5.07 COMBINED APPLICATION FOR A MATERIAL CHANGE OF USE FOR A RETIREMENT FACILITY (DEVELOPMENT PERMIT FOR STAGE 1 AND PRELIMINARY APPROVAL FOR STAGE 2) AND LOT RECONFIGURATION (1 INTO 2 LOTS)

Johnston Road, Mossman Gorge

Lot 1 on RP150474

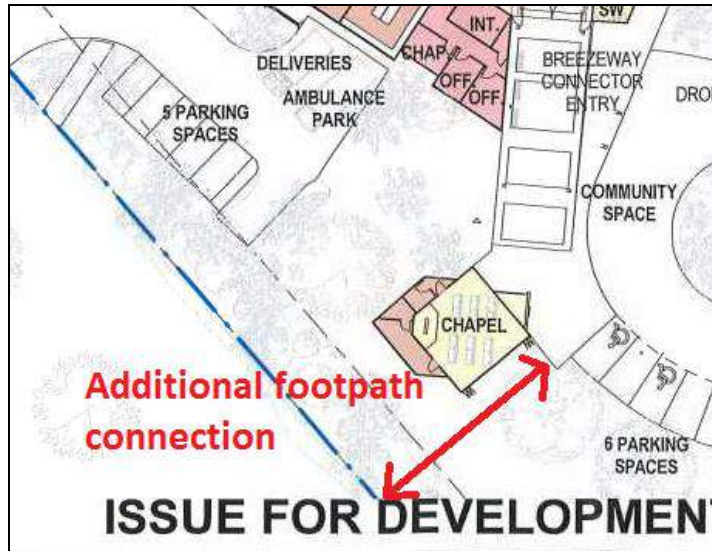
3. The proposed building / development must be amended to accommodate the following changes:
 - a. Provide a direct footpath to Johnston Road in the vicinity of the Chapel connecting to the Breezeway Connector Entry (see below).

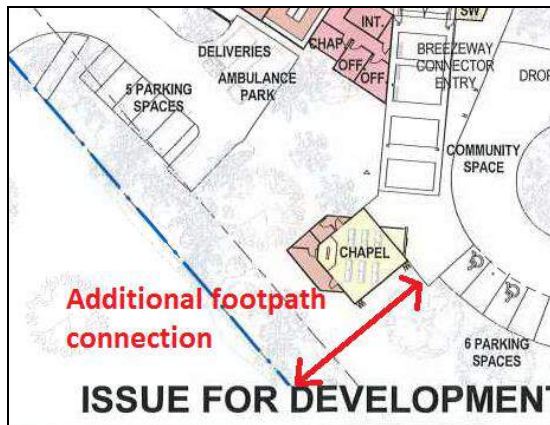
The addition of an additional pedestrian footpath between the breezeway connector and Johnston Street in the vicinity of the chapel will provide a more convenient pedestrian entry connection for the majority of pedestrians visiting the site. An adjustment is recommended (see below).

A condition has been applied accordingly.

Lot Boundary Between proposed Lot 1 and Lot 2

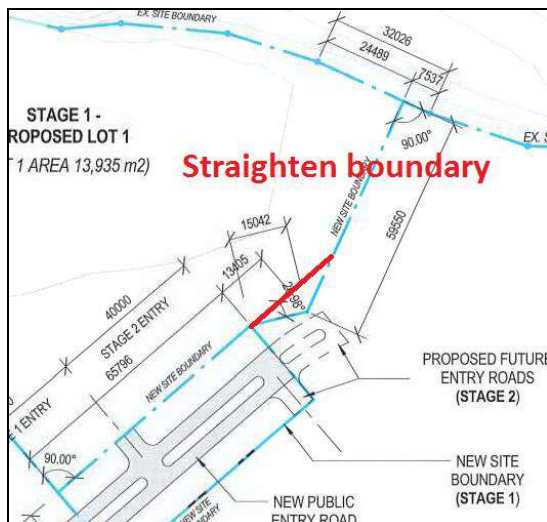
2. Straighten the boundary between proposed lots 1 and 2 to remove the kink in the common boundary at the end of the proposed road reserve (see below)

The lot boundary proposed between Lot 1 and 2 kinks awkwardly at the end of the proposed new road which will create problems when the private section of the road is extended into Stage 2 (see below).

A condition has been applied accordingly.
